Item ID: D350-607-545 Accept ***N900040100*** Setup Start ***NS1***
Revision ID: Stop ***NS2***
Item Name: AS350/AS355 Quick Release Heli-Utility-Basket™, Short, Heavy Duty Lid
Start Date: 5/4/2017 Start Qty: 1.00 ***1*** Cust Item ID:
Required Date: 5/12/2017 Req'd Qty: 1.00 ***1*** Customer:
Reference: SCHEDULED/C

DART SERVICE INSTRUCTION

**TO AMEND INSTALLATION INSTRUCTIONS D350-607-3 Rev.D,
INSTALLATION INSTRUCTIONS D350-607-4 Rev. C AND
INSTRUCTIONS FOR CONTINUED AIRWORTHINESS ICA-D350-607 REV. 6**

A	NEW ISSUE	AJS	14.05.16
REV.	DESCRIPTION	BY	DATE
DESIGN	AJS	DART AEROSPACE LTD	
DRAWN	AJS	HAWKESBURY, ONTARIO, CANADA	
CHECKED		DRAWING NO.	REV. A
MFG. APPR.	N/A	DSI 9699	SHEET 1 OF 2
APPROVED		TITLE	SCALE
DE APPR.		LUG REPLACEMENT	NTS
DATE	14.05.16	COPYRIGHT © 2014 BY DART AEROSPACE LTD THIS DOCUMENT IS PRIVATE AND CONFIDENTIAL AND IS SUPPLIED ON THE EXPRESS CONDITION THAT IT IS NOT TO BE USED FOR ANY PURPOSE OR COPIED OR COMMUNICATED TO ANY OTHER PERSON WITHOUT WRITTEN PERMISSION FROM DART AEROSPACE LTD.

FIGURE 1: INSTALLATION OF D4775-041 FWD STRUT

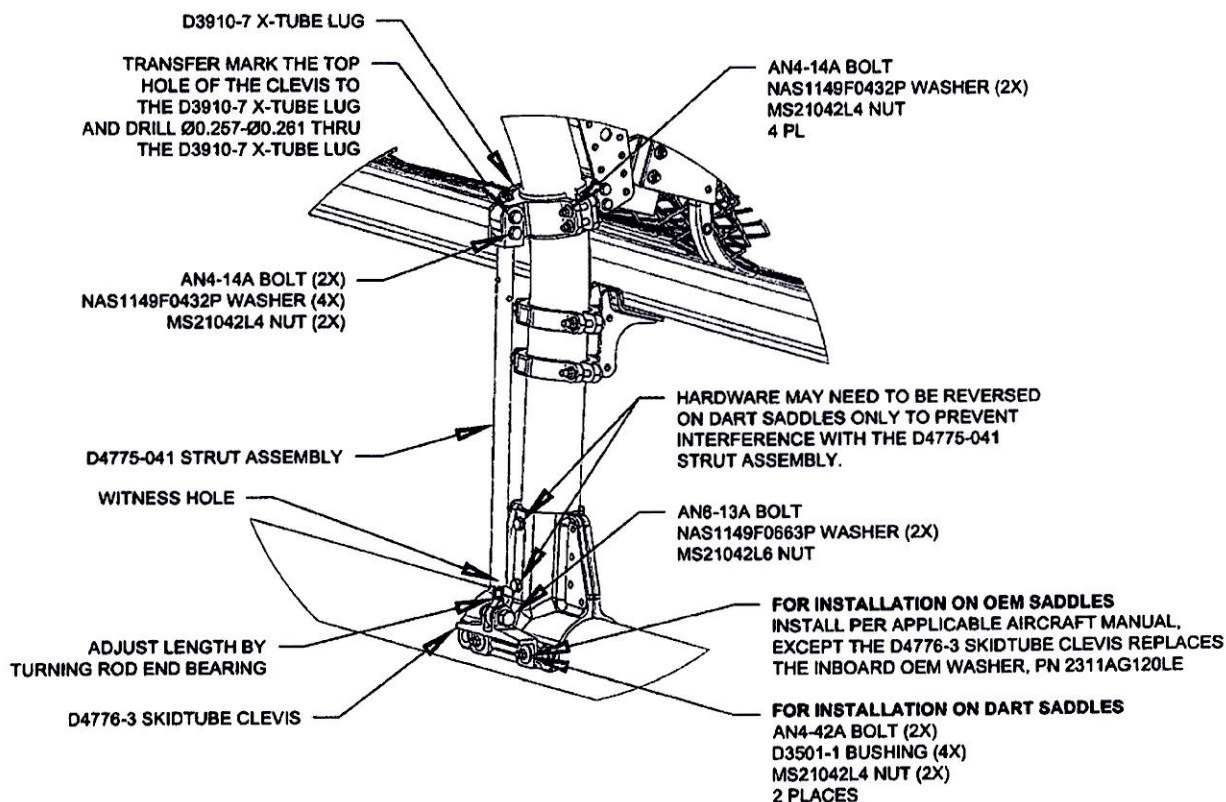
- 3.1 Substitute the Forward Lower D3910-5 X-Tube Lug with the D3910-7 X-Tube Lug as shown in Figure 1.
- 3.2 Install the forward D4775-041 Strut Assembly. Transfer mark from the upper hole on the clevis of the D4775-041 Strut Assembly to the D3910-7 X-tube Lug and drill thru the lug $\varnothing 0.257$ - $\varnothing 0.261$ as shown in Figure 1. Touch up chemical conversion coating per MIL-DTL-5541. Check the witness holes located at the bottom end of the D4775-041 Strut Assemblies to ensure that the thread from the rod end extends past the witness hole.
Torque MS21042L4/-4 nuts to 50-70 in-lbs (5.7-7.9 N-m). Torque MS21042L6/-6 nuts to 160-190 in-lbs (18.1-21.5 N-m).
- 3.3 Complete the installation in accordance with Installation Instructions D350-607-3 Rev. D or D350-607-4 Rev. C.
